MEMORANDUM

From: Mary O'Neil, AICP, Principal Planner **RE**: ZP21-509 72-76 Elmwood Avenue

Request: Build three unit detached residential structure on the site of the former Free Methodist Church. One existing single family residence remains on site. (Planned Unit Development)

West elevation (facing Elmwood Avenue)

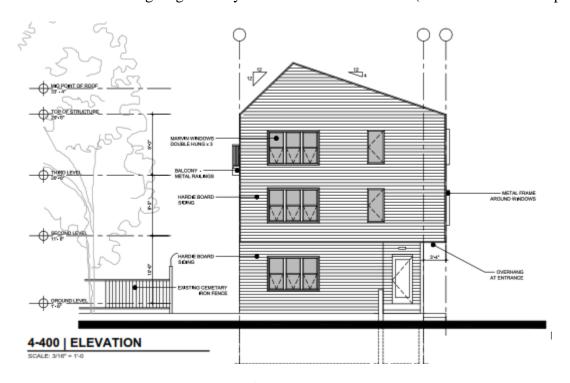
The new building will shoulder-up to Elmwood Avenue; filling the emptiness left by the loss of the Church. In placement it fills the hole in the streetscape and maintains the development pattern and rhythm of structures along the street. A principal entrance fronting onto Elmwood Avenue has been introduced consistent with these regulations:

Although presenting eaves-front to the street, the height and massing of the proposed building is consistent with other structures in the immediate area.

As designed, the building lacks typical façade articulation such as bays, horizontal and vertical façade articulation, porches, patios, articulated bases, step-backs or other street level details. Windows are stacked, however, providing a measure of arrangement. The plan is modernistic with a simplified form and little detailing. The only interest provided is the angular and asymetrical roof line.

- Any intended mechanical equipment (HVAC, Condensing Units, mini-splits, etc) shall be illustrated on the site plan/building elevations as appropriate. No mechanical equipment shall be allowed on the primary (westerly) elevation. Screening may be required elsewhere.
